TVA-BFN-TS-425

**BROWNS FERRY NUCLEAR PLANT (BFN) - UNITS 2 AND 3 - TECHNICAL
SPECIFICATIONS (TS) CHANGE 425 - FRAMATOME FUEL - CORE OPERATING
LIMITS REPORT (COLR) REFERENCES**

Technical Specifications (TS) Change 425

Proposed Technical Specifications Changes (mark-up)

5.6.5 CORE OPERATING LIMITS REPORT (COLR)

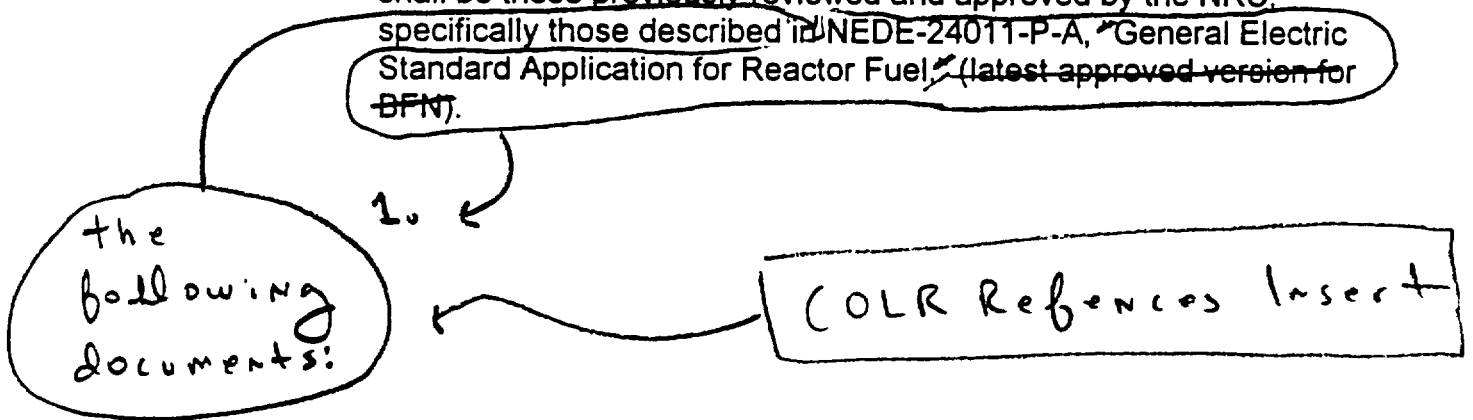
- b. The analytical methods used to determine the core operating limits shall be those previously reviewed and approved by the NRC, specifically those described in NEDE-24011-P-A, "General Electric Standard Application for Reactor Fuel," (latest approved version for BFN).

COLR References Insert

2. XN-NF-81-58(P)(A), RODEX2 Fuel Rod Thermal-Mechanical Response Evaluation Model.
3. XN-NF-85-67(P)(A), Generic Mechanical Design for Exxon Nuclear Jet Pump BWR Reload Fuel.

4. EMF-85-74(P)(A), RODEX2A (BWR) Fuel Rod Thermal-Mechanical Evaluation Model.
5. ANF-89-98(P)(A), Generic Mechanical Design Criteria for BWR Fuel Designs.

6. XN-NF-80-19(P)(A) Volume 1, Exxon Nuclear Methodology for Boiling Water Reactors - Neutronic Methods for Design and Analysis.
7. XN-NF-80-19(P)(A) Volume 4, Exxon Nuclear Methodology for Boiling Water Reactors: Application of the ENC Methodology to BWR Reloads.

8. EMF-2158(P)(A), Siemens Power Corporation Methodology for Boiling Water Reactors: Evaluation and Validation of CASMO-4/MICROBURN-B2.
9. XN-NF-80-19(P)(A) Volume 3, Exxon Nuclear Methodology for Boiling Water Reactors, THERMEX: Thermal Limits Methodology Summary Description.

10. XN-NF-84-105(P)(A) Volume 1, XCOBRA-T: A Computer Code for BWR Transient Thermal-Hydraulic Core Analysis.
11. ANF-524(P)(A), ANF Critical Power Methodology for Boiling Water Reactors.

12. ANF-913(P)(A) Volume 1, COTRANSA2: A Computer Program for Boiling Water Reactor Transient Analyses.
13. ANF-1358(P)(A), The Loss of Feedwater Heating Transient in Boiling Water Reactors.

14. EMF-2209(P)(A), SPCB Critical Power Correlation.
15. EMF-2245(P)(A), Application of Siemens Power Corporation's Critical Power Correlations to Co-Resident Fuel.

16. EMF-2361(P)(A), EXEM BWR-2000 ECCS Evaluation Model.
17. EMF-2292(P)(A), ATRIUM™-10: Appendix K Spray Heat Transfer Coefficients.
